CALL NO. 106
CONTRACT ID NO. 181230
ADDENDUM # 1

Subject: JEFFERSON COUNTY, STP 8751 (017)
Letting September 21, 2018

**POPLAR LEVEL (KY 864) PAVEMENT REHABILITATION
JEFFERSON COUNTY MILEPOST 7.111-11.438
ITEM NUMBER: 5-20023.00
GENERAL SUMMARY**

CHEVRON PAVEMENT MARKINGS DETAIL

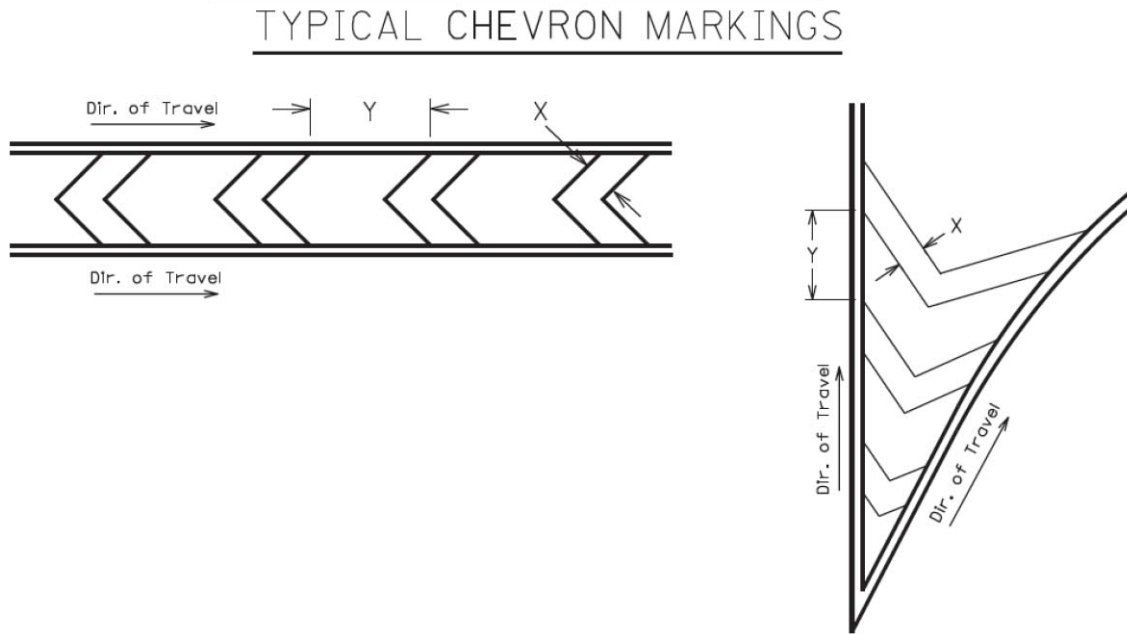
- (1) Revised - Pavement Rehab General Summary Sheet - Page 32 of 198
- (2) Added - Striping Quantity Summary Sheet - Page 53(a) of 198
- (3) Revised - Special Notes References - Page 68 of 198
- (4) Added - Chevron Pavement Markings Detail Sheet - Page 91(a) of 198
- (5) Revised - Proposal Bid Items - Pages 197-198 of 198

The chevron pavement marking width (X) and spacing (Y) will usually be specified in the plans. The width to spacing values usually have a ratio of 1:10. If the plans do not specify the width (X) and spacing (Y) the Engineer will provide the contractor with the X and Y values for each chevron installation. If necessary, the Engineer may obtain guidance from the District Traffic Engineer and/or the Division of Traffic Operations.

NOTE: Adjust the width and spacing of the chevron pavement markings as necessary so that a minimum of three (3) chevron markings are placed within the area being marked. The 1:10 ratio between width and spacing values should be maintained as much as possible.

The Department will measure the finished in-place area of Chevron Pavement Markings in Square Feet. The Department will NOT measure overlaps or the void space between the chevrons. See Section 717.04 for additional measurement information.
